REGIONAL MEMORANDUM

**GUIDELINES ON THE USE OF SCHOOLS AS EVACUATION CENTERS DURING
PANDEMIC AND THE URGENT REPAIR AND REPLACEMENT OF
CEILINGS IN SCHOOLBUILDINGS**

AIDE MEMOIRE

**URGENT NEED TO REPAIR AND REPLACE
CEILINGS OF SCHOOLBUILDINGS
CONSTRUCTED BY FROM 2014-2019**

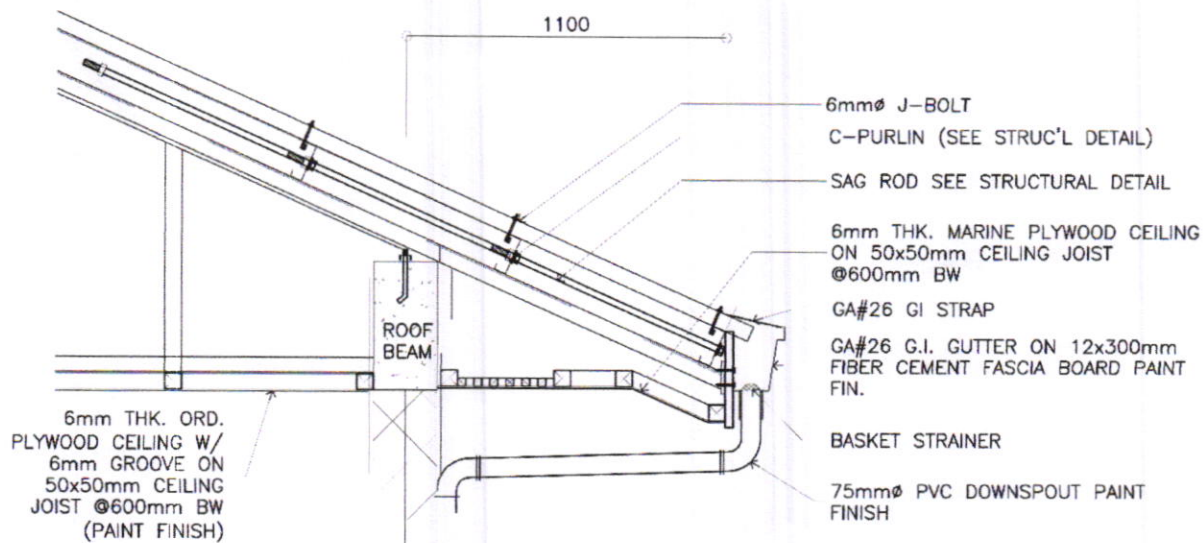
Before 2014, DepEd already adopted the use of suspended ceilings in its standard School Building Designs composed of wooden materials specifically 50mm X 50mm ceiling hangers and ceiling joists spaced at 600mm with ordinary and marine Plywood ceiling (see picture below). The use of wood has several advantages: unlike metal, wood does not conduct heat and this increases thermal comfort or keeps classrooms cooler; plywood, unlike ficem boards, is definitely easier to work with, especially when cutting manholes (or handholes) for future utility maintenance access inside ceiling (*kisame*).

SECTION

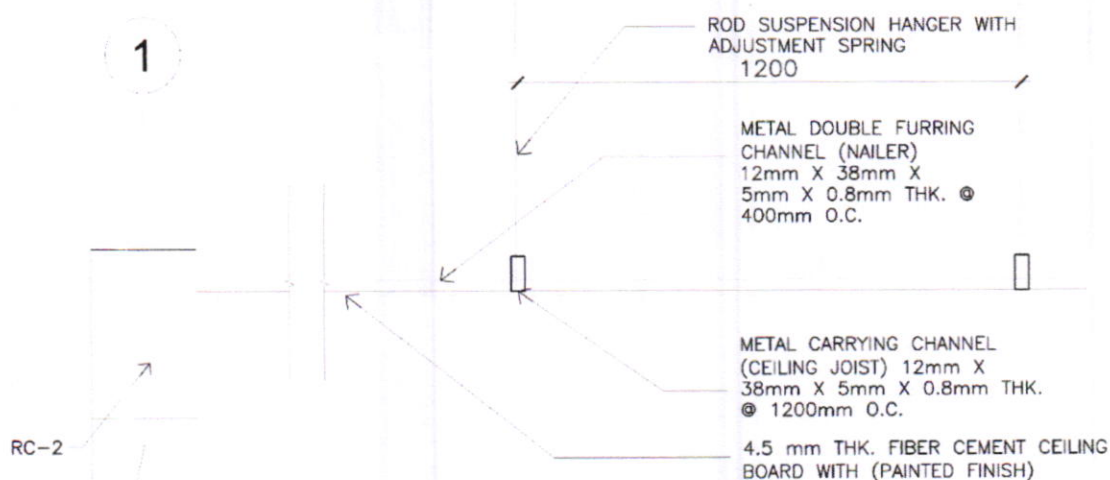
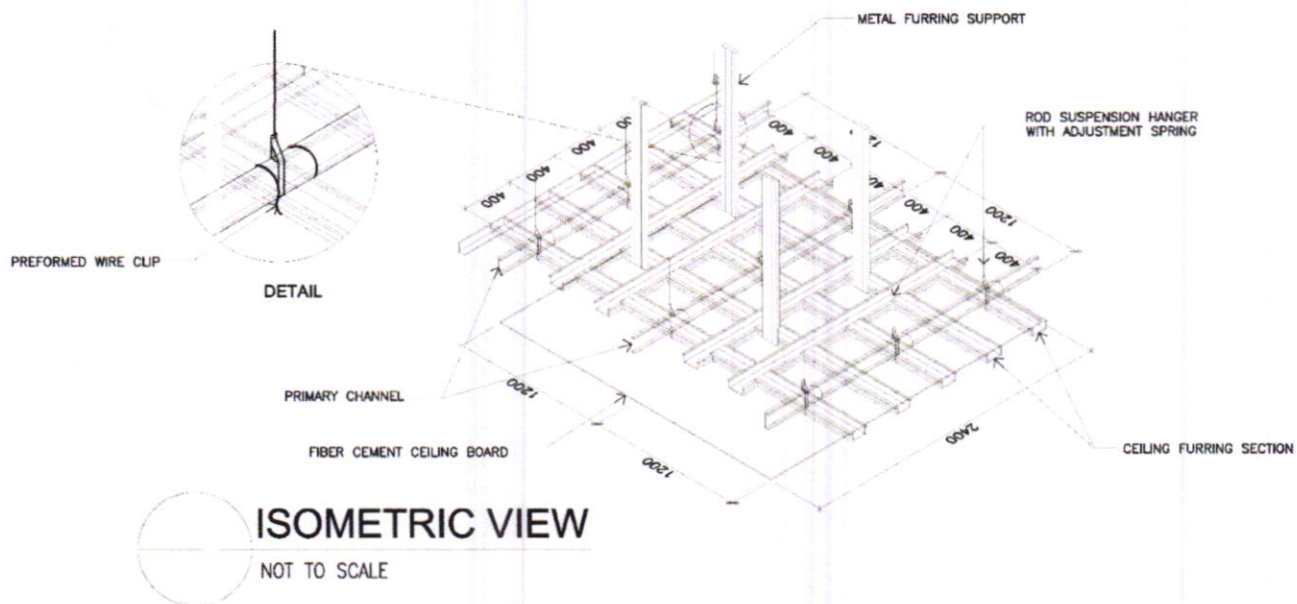
When **DPWH** reviewed the designs of the school buildings in **2014**, the materials used for the ceiling was changed from the conventional wooden type ceiling hangers and joists and marine plywood, to metal furring and fiber cement ceiling board. It can be clearly seen in the design drawings that the spacing of metal furring is set at 400mm X 400mm, using metal carrying C-channels.

The design specifications were apparently not followed in actual construction: not only were metal C-channels spaced farther apart, there was inadequate and fewer metal furring supports/hangers, as evidenced in the pictures of collapsed ceilings shown in the succeeding pages of this document.

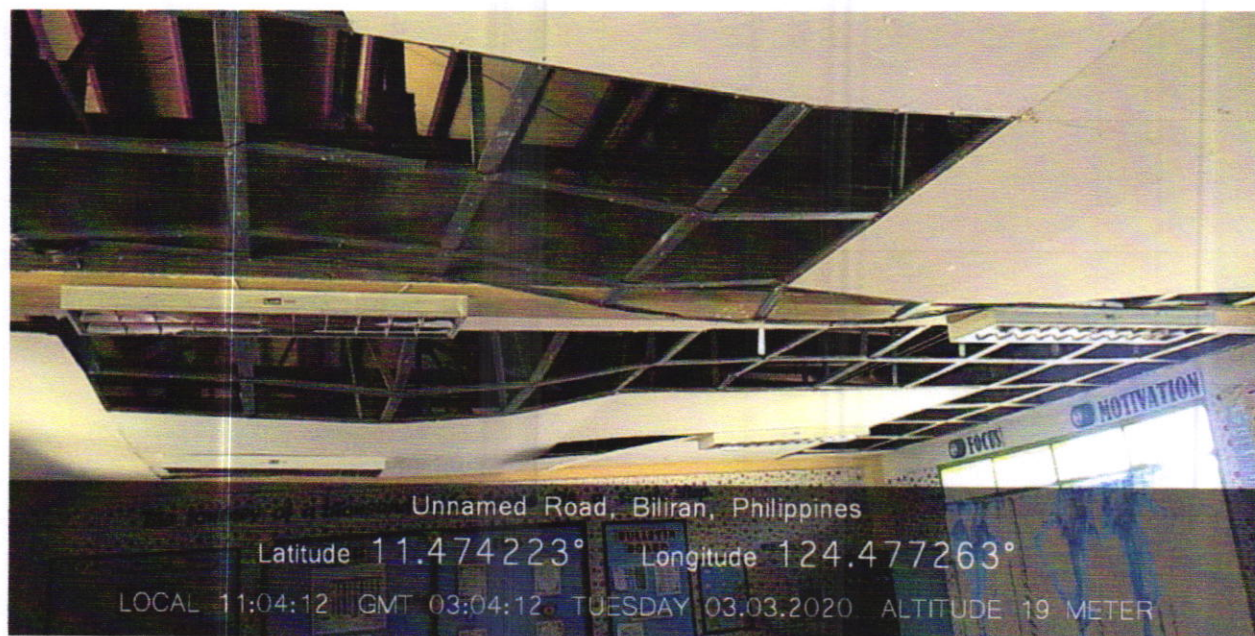
The **first incident of collapsed ceiling was reported in Ramon de Santos NHS, Cuyapo, Nueva Ecija.** The incident happened in **November 2017 under normal weather condition.** The said incident was broadcasted in local media outfits which led the DPWH contractor to shoulder the expenses of hospitalization and medicines of injured students and the reconstruction of the collapsed ceiling without any additional cost to the government.

Matacon NHS, Albay collapsed ceiling due to Typhoon Tisoy

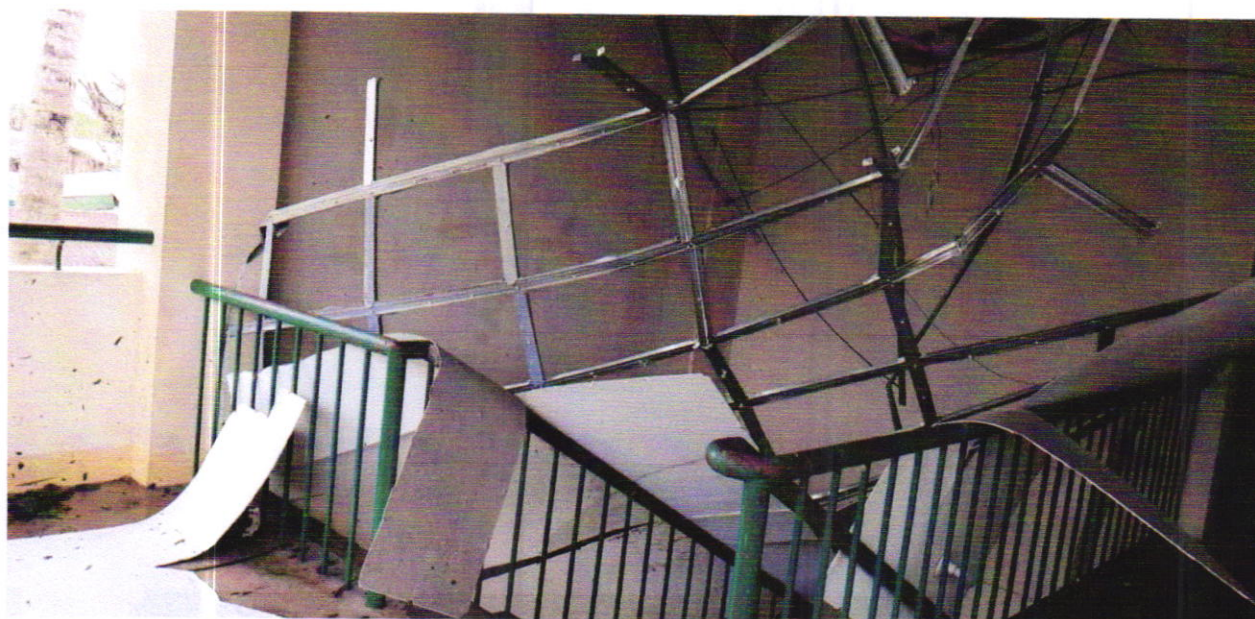
Several incidents followed and were recorded by the Regional and Division Offices of DepEd particularly after a series of earthquakes and other natural calamities struck the country.

Domingo Lacson National High School

Collapsed Ceilings due to Earthquakes

Collapsed Ceiling due to Typhoons
